Varna Wind, Inc.

Amendment to the Design and Operations Report – Bluewater Wind Energy Centre

Project Number: 60301207

Date: September, 2013

Table 2-1 Summary of Project Modifications

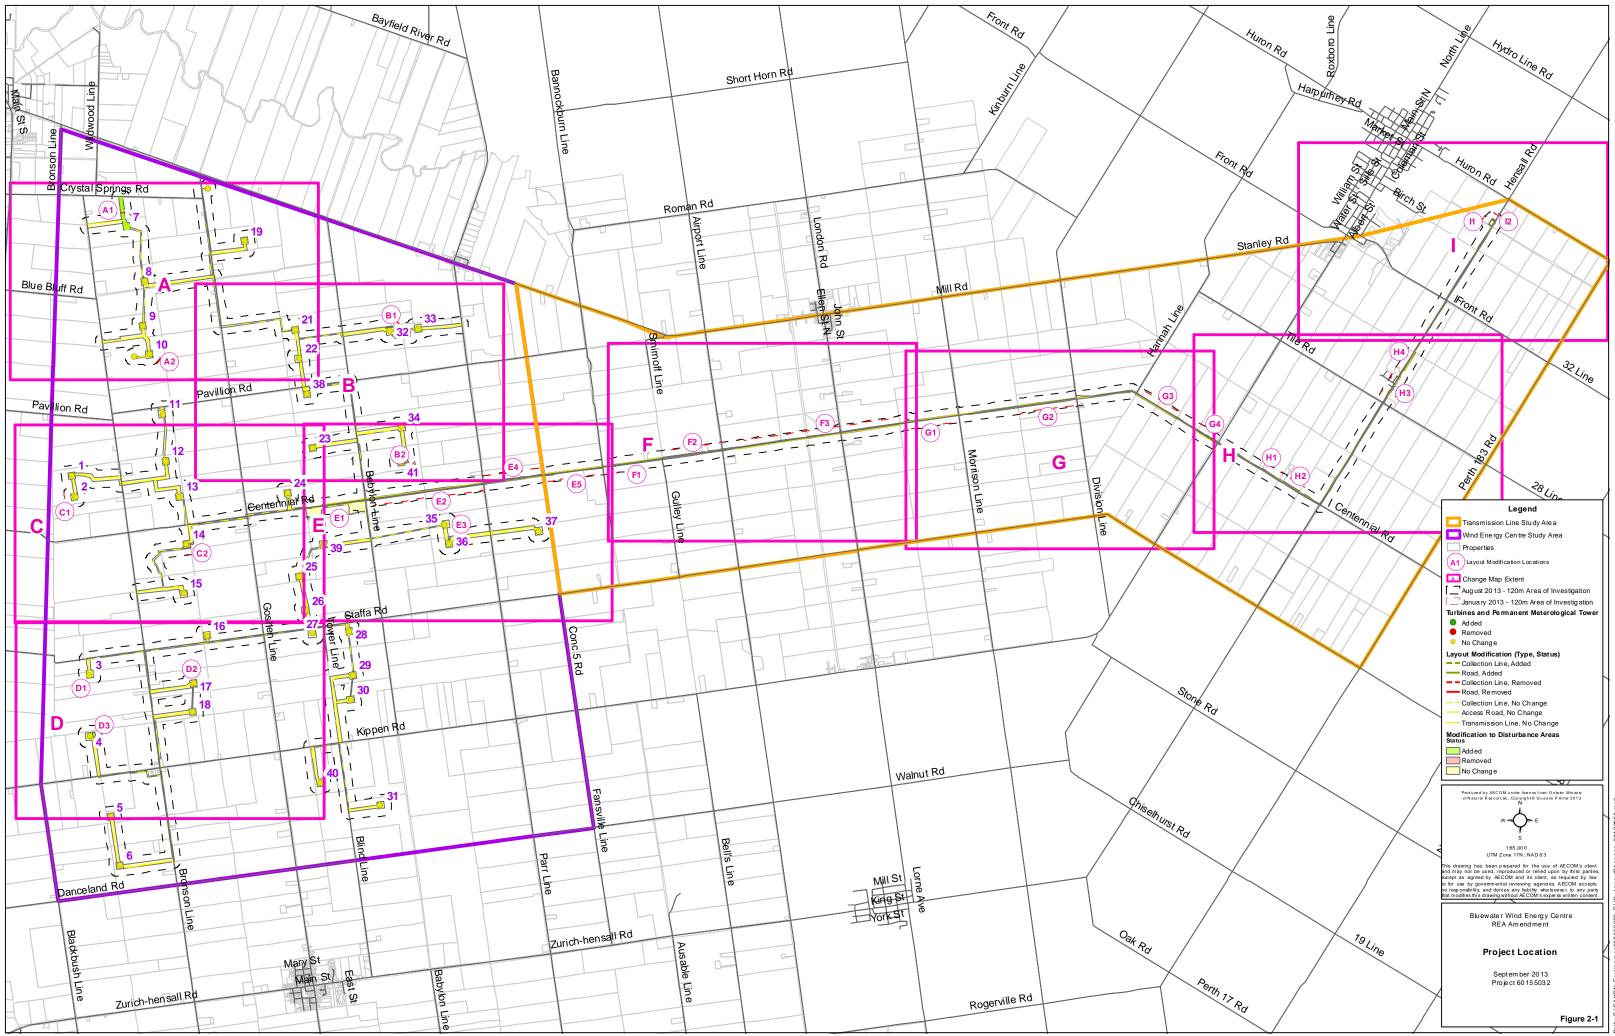
Label on Figure 2-1	Proposed Modification	Rationale for Proposed Modification	New Potential Environmental Effects	New Mitigation Measures
A1	Addition of road to Turbine 7 to travel north towards Crystal Springs Road	Infrastructure or construction disturbance area added or changed to optimize project design/ constructability	None – no new natural heritage or water body features within 120 m; area previously studied for cultural heritage	N/A
A2	Removal of construction disturbance area to the south east of Turbine 10	Construction disturbance area modified to reduce or eliminate impacts to Conservation Authority regulation limit	None – no new natural heritage or water body features within 120 m; area previously studied for cultural heritage	N/A
B1	Addition of construction disturbance area to the north of Turbine 32	Construction disturbance area added or changed to optimize project design/ constructability	None – no new natural heritage features within 120 m; area previously studied for cultural heritage and water body features	N/A

B2	Addition of construction disturbance area to the east of Turbine 41	Construction disturbance area added or changed to optimize project design/ constructability	None – no new natural heritage features within 120 m; area previously studied for cultural heritage and water body features	N/A
C1	Addition of construction disturbance area to the west of Turbine 2	Construction disturbance area added or changed to optimize project design/ constructability	None – no new natural heritage or water body features within 120 m; area previously studied for cultural heritage	N/A
C2	Addition of construction disturbance area to the south and east of Turbine 14	Construction disturbance area added or changed to optimize project design/ constructability	None – no new natural heritage or water body features within 120 m; area previously studied for cultural heritage	N/A
D1	Removal of construction disturbance area to the south west of Turbine 3	Construction disturbance area modified to reduce or eliminate impacts to Conservation Authority regulation limit	None – no new natural heritage features within 120 m; area previously studied for cultural heritage and water body features	N/A

D2	Addition of construction disturbance area to the south of Turbine 17	Construction disturbance area added or changed to optimize project design/ constructability	None – no new natural heritage or water body features within 120 m; area previously studied for cultural heritage	N/A
D3	Addition of construction disturbance area to the east of Turbine 4	Construction disturbance area added or changed to optimize project design/ constructability	None – no new natural heritage or water body features within 120 m; area previously studied for cultural heritage	N/A
E1 – E2	Addition of construction disturbance area for the transmission line in the municipal road right-of-way along Centennial Road	Construction disturbance area added or changed to optimize project design/ constructability	None – no new natural heritage features within 120 m; area previously studied for cultural heritage and water body features	N/A

E3	Addition of construction disturbance area to the north of Turbine 36	Construction disturbance area added or changed to optimize project design/ constructability	None – no new natural heritage or water body features within 120 m; area previously studied for cultural heritage	N/A
E4	Addition of construction disturbance area for the transmission line on private property to the north of Centennial Road	Construction disturbance area added or changed to optimize project design/ constructability	None – no new natural heritage or water body features within 120 m; area previously studied for cultural heritage	N/A
E5	Addition of construction disturbance area for the transmission line in the municipal road right-of-way along Centennial Road	Construction disturbance area added or changed to optimize project design/ constructability	None – no new natural heritage or water body features within 120 m; area previously studied for cultural heritage	N/A

F1	Addition of construction disturbance area for the transmission line in the municipal road right-of-way along Centennial Road	Construction disturbance area added or changed to optimize project design/ constructability	None – no new natural heritage features within 120 m; area previously studied for cultural heritage and water body features	N/A
F2	Addition of construction disturbance area for the transmission line on private property to the north of Centennial Road	Construction disturbance area added or changed to optimize project design/ constructability	None – no new natural heritage or water body features within 120 m; area previously studied for cultural heritage	N/A
F3	Addition of construction disturbance area for the transmission line in the municipal road right-of-way along Centennial Road.	Construction disturbance area added or changed to optimize project design/ constructability	None – no new natural heritage or water body features within 120 m; area previously studied for cultural heritage	N/A

G1 – G4	Addition of construction disturbance area for the transmission line in the municipal road right-of-way along Centennial Road	Construction disturbance area added or changed to optimize project design/ constructability	None – no new natural heritage or water body features within 120 m; area previously studied for cultural heritage	N/A
H1	Addition of construction disturbance area for the transmission line on private property to the north of Centennial Road	Construction disturbance area added or changed to optimize project design/ constructability	None – no new natural heritage or water body features within 120 m; area previously studied for cultural heritage	N/A
H2	Addition of construction disturbance area for the transmission line on private properties to the north of Centennial Road	Construction disturbance area added or changed to optimize project design/ constructability	None – no new natural heritage or water body features within 120 m; area previously studied for cultural heritage	N/A

H3 – H4	Addition of construction disturbance area for the transmission line in the municipal road right-of-way along Hensall Road	Construction disturbance area added or changed to optimize project design/ constructability	None – no new natural heritage features within 120 m; area previously studied for cultural heritage and water body features	N/A
11	Addition of construction disturbance area for the transmission line POI to the north of the existing disturbance area	Construction disturbance area added or changed to optimize project design/ constructability	None – no new natural heritage or water body features within 120 m; area previously studied for cultural heritage	N/A
12	Addition of construction disturbance area for the transmission line in the municipal road right-of-way along Hensall Road	Construction disturbance area added or changed to optimize project design/ constructability	None – no new natural heritage or water body features within 120 m; area previously studied for cultural heritage	N/A
